**KANEPACKAGE PHILIPPINE INC.**

INVESTIGATION REPORT FORM (IRF)

Customer	HIBLOW PHILIPPINES INC.	Attention To	REXEL ALMARIO
Item Code	DB08005130-00	Department	PRODUCTION
Item Description	XP BOX PROTOTYPE OUTER BOX AND INSERT PAD	Date of Detection	250503
Job Order Number	JO25-M-01315-1	Section Detected	QA SCREENING

ILLUSTRATION OF THE PROBLEM

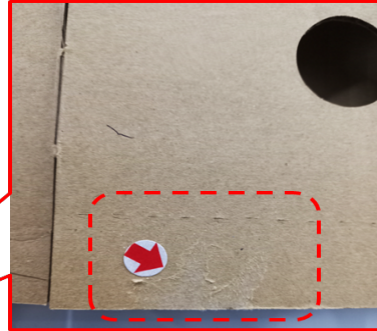
PEEL OFF

ACTUAL: With peel off up to 30mm**REQUIREMENT:** Acceptable up to 25mm

WHY 1 : PEEL OFF OCCURRED DURING DETACHING PROCESS

WHY 2 : PRESENCE OF UNCUT LINER DURING ETERNA PROCESS

WHY 3 : IMBALANCE DIECUT PRESSURE DUE TO UNEVEN APPLICATION OF BACKING TAPE

WHY 1: APPLICATION OF BACKING TAPE TO THE AFFECTED PORTION
